Council Comments (February 2023)	FPA Response	Reference Drawings																																																												
1. Land Use Planning There are discrepancies between the proposed GFA for Stage 1A shown in different area schedules. The area schedule in the Stage 1A Design Report Appendix shows a proposed total GFA of 37,096sqm, the area schedule in Appendix C2 and the Clause 4.6 for Stage 1A has a total GFA of 36,967sqm. These discrepancies need to be addressed.	The proposed Stage 1A GFA is 37,130sqm and has been updated across all documentation. Based on a Stage 1A site area of 18,150sqm, the maximum permissible GFA is 39,930sqm. This comprises application of: - a base FSR of 1.7:1 under the PLEP 2011 resulting in a maximum permissible base GFA of 30,855sqm; and - a bonus FSR of 0.5:1 under clause 6(2) and 1392) of the Affordable Rental Housing SEPP resulting in 9,075sqm. The proposed GFA is 2800sqm below the maximum permissible GFA. Accordingly, a clause 4.6 variation request is not required.	- Stage 1A DA Design Report pg.12, 73, 74, 81 - Stage 1A Telopea Development Schedule <table><tr><td>Site Area (excl RE1)</td><td>18,150sqm</td></tr><tr><td>Base 1.7:1 FSR</td><td

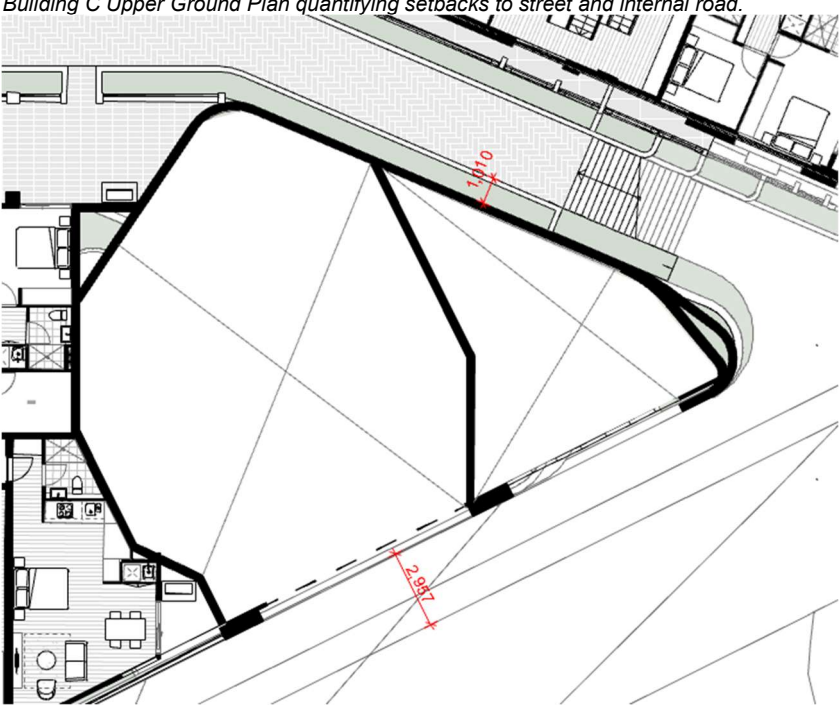
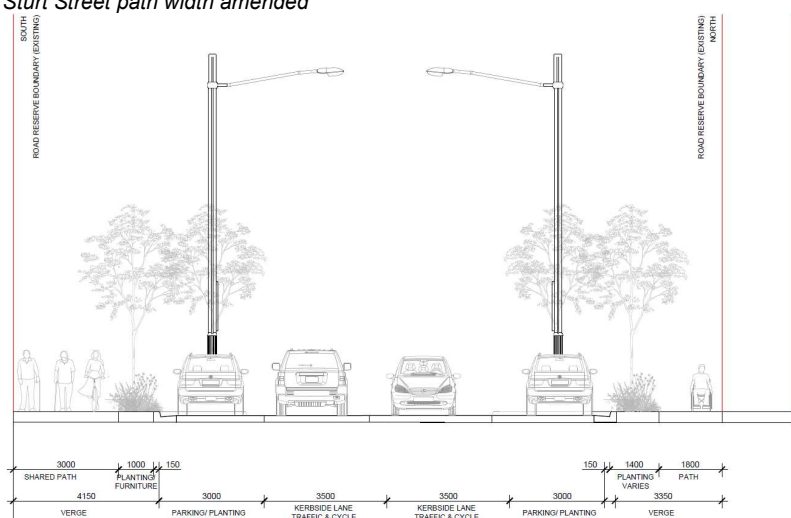
The connection of carparking basement between Building C and D is not supported and should be redesigned as two separate structures on site. The driveway access point from the south of Building D and C is sufficient to allow for vehicle movement into the carparks below these buildings and therefore the basement connection cannot be justified. The extent of basement decreases deep soil for the south of the Neighbourhood Park and the avenue of trees aligned to Mews Street. By reducing deep soil, it reduces the growth of mature canopy sizes which impacts heat island effect. Deleting the basement means that the whole of the link from Manson Street can remain public. This is recommended. Council will not accept any land dedication above basement levels. If the connection of carparking basement between Building C and D remains, the provision of sufficient soil depth to support planting over the basement link between buildings must be clearly demonstrated. The drawings also show no tree	The connecting car park basement between Bld C & D is proposed to: - enable a consolidated loading dock to be provided, which will be accessed through Building C; - avoid generating additional vehicular congestion and compromised pedestrian at ground level that would inevitably arise from providing separate basements - achieve greater efficiency through the consolidation of required ramping infrastructure; and - reduce the level of excavation that would otherwise be required if separate basement structures were required to be constructed to support individual buildings. - Removal of Winter Street basement access, in consultation with the community. The proposed connection of the Building B/Building C basement does not compromise deep soil planting across the Stage 1A Project Application site area. The total deep soli area proposed across Stage 1A is 3,550sqm (19.6%) across the R4 High Density Residential zoned land, which significantly exceeds the ADG's recommended minimum guidance of 7%.of the Stage 1A's 18,150sqm site area. In response to Council's soil depth comments, the design team has amended the architecture, landscape architecture and civil drawings with corresponding RL and SSL. The revised drawings indicate that all trees are proposed to have a minimum depth of	- Stage 1A DA Design Report pg.22. - PLA-AR-DA0099 LOWER GROUND FLOOR PLAN - Telopea Urban Renewal Stage 1A-1 Public Domain Landscape Works Development Application - Telopea Urban Renewal Stage 1A-2 Residential Landscape Works Development Application - Hassell/Bates Smart Telopea Urban Renewal Public Domain Plan pg.42 - Hassell Stage 1A Landscape plans

Council Comments (February 2023)	FPA Response	Reference Drawings
vegetation in this area, and such an outcome is not supported by Council officers. Provide enough design detail (specific section relative to ground level) to confirm the following: • Minimum 1m clear soil depth, excluding mulch and drainage layers, over basement carpark deck to support soft landscaping including trees of all sizes. • Large contiguous soil body zones supporting multiple trees and plants. A series of isolated, disparate containerised zones is not acceptable. • A landscape design showing large trees planted over the basement link (if not removed as recommended) to match the rest of the park area. • Basement carparking extent should be reduced particularly from boundaries and sit within building footprints. This is to allow for deep soil tree planting which supports large tree growth. Basement carpark to the Northern boundary of building C should be setback 4m. • A number of the communal open spaces have the basement extending significantly into them. Basement should be reduced to allow for greater planted amenity within the communal open space.	1200mm, allowing for a minimum of 1m soil depth, with 200mm allowance for mulch, drainage layers, etc. The proposed soil volumes will ensure the long-term health of trees, matching the trees in the public domain within deep soil.	Lower Ground Floor  Deep Soil Zones  Deep Soil 3,550 m² 19.6% of Site Area Planting soil depth above basement link

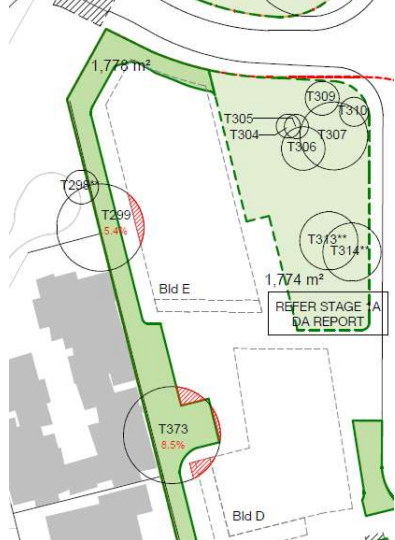
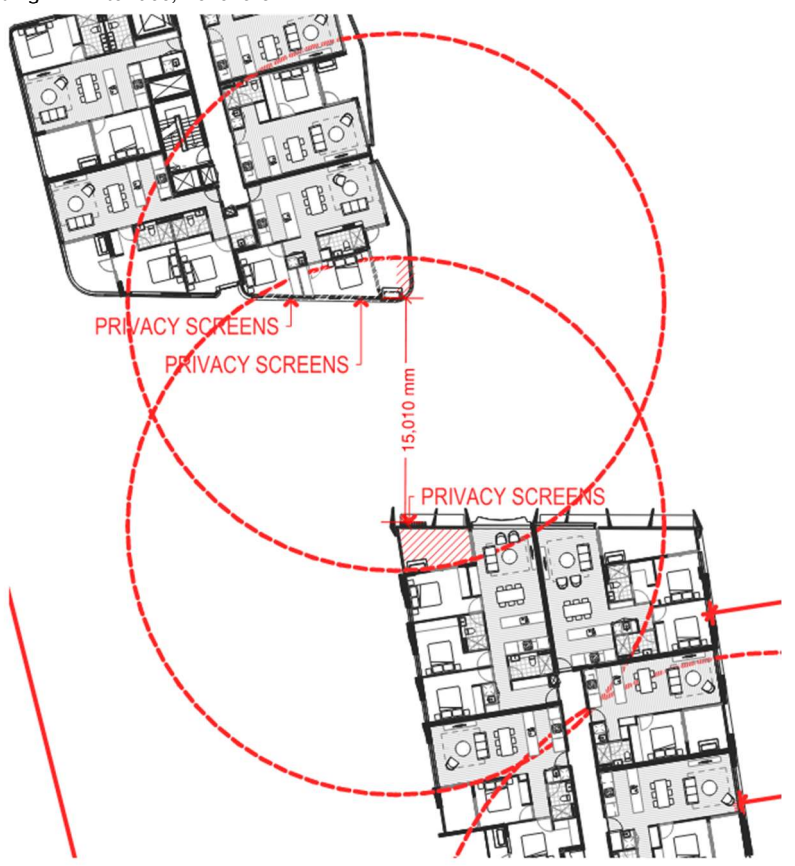
Ground level front setbacks have been amended and are improved however the following changes are still sought: - Sturt Street – 6m minimum ground level and basement car park setback for Stage 1A. This will improve the deep soil area available for trees, mimic the proposed setback to the Core on the other side of Sturt Street and increase the depth of private balconies or gardens for residents from the street. - An increased setback to Mew Street could improve the pedestrian experience and increase areas for tree planting. - Setbacks along the new internal road for Eastern side of Building C Ground Floor is only 2m with 0.50m of planting. Setback should be increased to allow for privacy and a larger planted outlook. - The Southern side of Building C has a 0m setback to the new internal roadway. Opportunities to increase this setback should be explored	Council's recommendations in respect of Sturt Street, Mew Street, the eastern side of Building C and the southern side of Building C have been considered by the design team as set out below. - Sturt Street Setback - Although Building B is setback 4m from façade to boundary and 3.6m from boundary to balconies, the majority of the Building B setback is 12m, from Sturt Street and therefore exceeds the recommended 6m setback. - Any further increases in setback would create an empty liminal streetscape between the Core Precinct and Stage 1A and reduce traffic and activation. - The proposed setback exceeds ADG separation requirements from the Core Precinct to the north and achieves the required solar amenity within Stage 1A. - The proposed generous street verge is sufficient to accommodate a variety of planting types and scale. - The setback is proposed to include both private and public planting to front the street. - The proposed quantum of deep soil area will support the planting of 29 generous trees within the public domain and pedestrian priority areas. - Generous terracing is provided on the ground level, and has the potential to offer further deep soil planting (above that already proposed) to support shrubbery and trees which will enhance the pedestrian experience mitigate privacy concerns. - A consistent 1.5m planting zone continues along the southern Sturt Street setback. To maximise the amenity planting brings to the streetscape, the landscape is arranged in two tiers, comprising a planting zone at the footpath level and a second higher planter that provides a planted buffer between streetscape and terraces. The proposed layering of planting (native grasses and shrubs) will soften the building edge, provide privacy to residents, and increase sense of separation between terraces and footpath. - In response to Council's comments regarding deep soil and street trees to Sturt Street (24 total), the continuous ground level planting zone has been increased from 500mm to 900mm – ensuring the success of street trees. The adjoining landscape verge within Sturt Street will further support the health of trees. - Mew Street Setback	- Stage 1A DA Design Report pg.20, 22, 57, 62, - PLA-AR-0099 LOWER GROUND FLOOR PLAN & PLA-AR-0100 UPPER GROUND FLOOR PLAN - PLA-AR-0202 BLDG. B NORTH ELEVATION - PLA-AR-0350 DEEP SOIL CALCULATIONS Hassell/Bates Smart Telopea Urban Renewal Public Domain Plan pg. 42 - Telopea Urban Renewal Stage 1A-2 Residential Landscape Works Development Application - Stage 1A DA Design Report pg. 63 - PLA-AR-0100 UPPER GROUND FLOOR PLAN - PLA-AR-0204 BLDG. B EAST & WEST ELEVATION - Telopea Urban Renewal Stage 1A-2 Residential Landscape Works Development Application - Stage 1A DA Design Report pg. 62, - PLA-AR-0100 UPPER GROUND FLOOR PLAN - PLA-AR-0204 BLDG. B EAST & WEST ELEVATION - Telopea Urban Renewal Stage 1A-2 Residential Landscape Works Development Application - PLA-AR-0099 LOWER GROUND FLOOR PLAN - PLA-AR-0206 BLDG. C ELEVATION Telopea Urban Renewal Stage 1A-2 Residential Landscape Works Development Application

Council Comments (February 2023)	FPA Response	Reference Drawings
	○ The proposed 5m setback to Mew Street from Buildings A and B (from glass line) is unable to be increased because it would erode the intimate streetscape envisioned in the masterplan and generate a higher, more uncomfortable level difference between footpaths and street (refer to section). ○ The setback of 5m is considered sufficient as Mews Street is a private internal street which is proposed to accommodate residential traffic compared to Sturt Street where larger planting would be promoted to create a buffer to heavy traffic. ○ The Mew Street setback has accordingly been designed to respond to these constraints and to achieve ADG building separation at the ground plane. ○ The setback is located on sloping terrain. Terraced planters, including trees and shrubbery, are proposed to ensure good levels of amenity are provided to pedestrians in the public domain while also ensuring appropriate levels of screening are provided to internal residential areas. ○ Fencing and raised planters proposed at the front boundary of the ground level terraces further enhance privacy and amenity for pedestrians on street level. ○ In addition, the proposed lush public domain further west of Mew Street further enhances this street condition. ○ The proposed landscape response demonstrably accommodates sufficient tree planting and achieves Council’s expectations for an improved pedestrian experience. ○ The proposed 9m setback to Mew Street from Buildings B and C (from glass line) is unable to be increased as it would erode the intimate streetscape with the generous public park. The separation is considered generous enough for a mix of planting options. ○ The Mews Street northern and eastern footpaths have been designed in accordance with Council’s Public Domain Guidelines with 1.8m footpaths and a continuous landscaped verge providing tree and groundcover planting (ranging from 1m to 2.5m wide). ○ Proposed 1m northern and eastern Mews verges are complimented by wider verges to southern and eastern carriageway verges. ○ Footpath widths are scaled for the anticipated resident and visitor patron volumes. The larger through-site link connection caters for higher volumes of precinct traffic. ● Setback to eastern side of Building C ○ The proposed setback of 1m is unable to be increased as it would create a wider separation that would erode the intimate pedestrian through-site link. This link runs for 20m (inclusive of stairs) and directly links to the public open space. ○ Podiums range between 1-4 stories and provide a dynamic and comfortable human scale pedestrian experience. ○ ADG separation at this interface has been achieved without any privacy impacts being created. ○ In response to the eastern façade’s location on sloping land, raised planting of shrubbery trees and fencing has been determined to be the most appropriate landscaping design response. ○ The eastern verge adjoining Building C is 2.8m wide, with a 1.8m footpath and 1m planting zone. ● Southern side of Building C ○ Building C has a 3m southern setback to the street as a direct response to services/ utilities planning, which should ideally be positioned away from the activated zones of the public domain.	<i>Building B North Elevation illustrating adequate landscaping</i>  <i>Building B Plan, façade facing Sturt Street illustrating approximately 1.65m deep zone for tiered planting.</i>

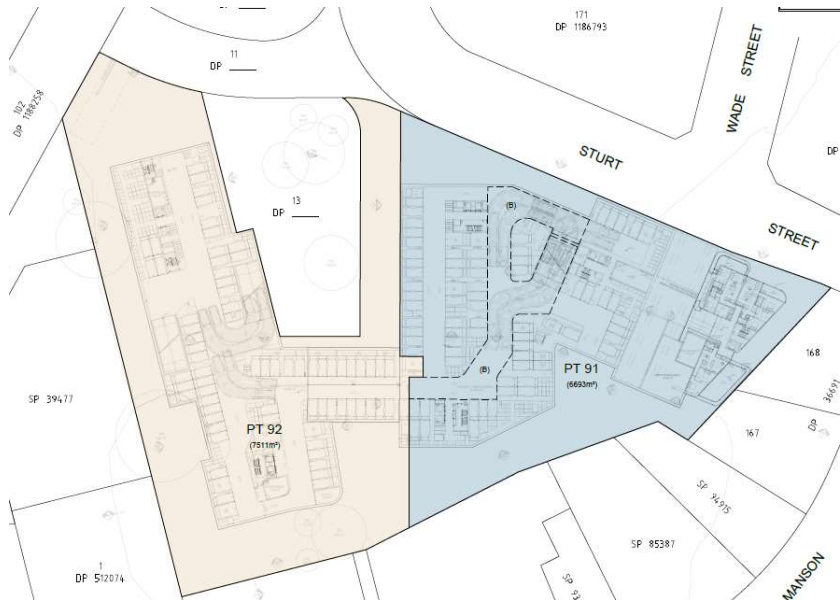
Telopea Masterplan envisaged a 9-storey height to the Stage 1A area. Building B and D, at 10 and 15 storeys respectively, is not in line with this vision. As such, any additional height increases are not supported, especially when it results in buildings that exceed the maximum height limit control in PLEP 2011. It is important to manage the height within the Stage 1A area to distinguish it from the denser Core on the other side of	Taller buildings within the Stage 1A Project Application site are the direct result of the SDRP process. In particular the SDRP voided feedback to the project team encouraging: <i>opportunities for a broader range of architectural expression should be investigated and these could include..... avoiding generic outcomes through appreciation of and emphasis on local character....greater height variation across the precinct –</i>	• Stage 1A DA Design Report pg.18, 20, 23, 25 • Scale Transition Diagram

<i>*Proposed height is approximated due to the complexity of the sloping terrain.</i> Building A sits well below the maximum permissible building height under PLEP 2011 (6m below the maximum height limit).	Building	PLEP 2011 Maximum Height (m)	Stage 1A Project Application Proposed Height (m)	Variance Approx (m)	Variance (%)	Building A	28m	18.58m	-9.42m	-33.6%	Building B	28m	48.88m	+20.88m	+74.5%	Building C	28m	31.90m	+3.90m	+13.9%	Building D	28m	32.12m	+4.12m	+14.7%	Building E	28m	30.13m	+2.13m	+7.6%	Due to the sloping terrain, buildings contain few sleeve apartments on lower ground levels which can be read as a storey higher at the boundaries. These buildings, however, are largely perceived as the storeys nominate in the diagram.
Building	PLEP 2011 Maximum Height (m)	Stage 1A Project Application Proposed Height (m)	Variance Approx (m)	Variance (%)																												
Building A	28m	18.58m	-9.42m	-33.6%																												
Building B	28m	48.88m	+20.88m	+74.5%																												
Building C	28m	31.90m	+3.90m	+13.9%																												
Building D	28m	32.12m	+4.12m	+14.7%																												
Building E	28m	30.13m	+2.13m	+7.6%

Council Comments (February 2023)	FPA Response	Reference Drawings
	Building B's proposed height is the result of careful master planning which seeks to achieve a GFA compliant scheme which focuses on; • Optimising Road networks and pedestrian connectivity – the linking between Telopea Light Rail Plaza and Mason Street towards the south and connection to Winter Street. • Maximising and activating open space between buildings to achieve high visual amenity, passive surveillance and solar amenity. • Creating smaller, fine grain building footprints which humanise the podium scale as to enhance pedestrian amenity and to avoid lengthy ground plane expression. As such, generous areas have been allocated within the heart of the development to a public park and pedestrian links, leaving ample site area for architectural development. The result is a fine grain development with a small footprint but taller scale. Buildings share brick podium base address the human pedestrian scale and diverse tower articulation and scale that address the future of Telopea. This design choice is far more sensible than a traditional massing strategy (stacked pancake form) which may result in larger footprints of consistent street facades which may be height compliant but unsympathetic to the future development and context of Telopea. (refer to diagram). Building B's proposed height is also contextualised against the adjoining Core Precinct and provides a transition in height between marker buildings adjacent to Telopea Station and the remainder of the Telopea Concept Plan Area. The proposed height exceedances of Buildings C, D and E are attributed to: • the site's topography which begins to fall steeply towards the site boundaries; • roof features; and • lift overruns. The distribution of height within the Stage 1A area has been carefully designed to distinguish it from the denser Core on the other side of Sturt Street and to provide a strong height transition away from the light rail stop and down into the lower-scale suburban areas. This is evident through the 'Scale Transition Diagram' which displays a steady transition in stories from western, eastern and southern frontages which front the low-rise residential context and culminates in the dense northern façade facing directly opposite the Core Precinct which hosts towers ranging from 14-24 storeys. The assessment supporting the Stage 1A Project Application (including the Environmental Impact Assessment, several Responses to Submissions, Stage 1A Design Reports, ADG compliance schedules and this entire design excellence package) collectively demonstrate that the increases in height do not result in significant impacts. Building separations, visual privacy and amenity have been addressed earlier in this feedback register. The proposed heights do not result in additional overshadowing, wind or visual impacts as demonstrated through the documentation submitted to date (refer to Response to Submissions, Urbis and Stage 1A Design Report, Rev J 23.07.28). The Clause 4.6 Stage 1A Building Height Variation Request prepared to support the proposed heights also demonstrates that compliance with the PLEP 2011 development standard is unreasonable and unnecessary on the basis that impacts would not be materially improved if compliance with the PLEP 2011 control was achieved. In fact, the project team has consistently demonstrated that a PLEP 2011 building height compliant scheme would result in larger building footprints and would consequently reduce the quantum and quality of open space and amenity to be provided.
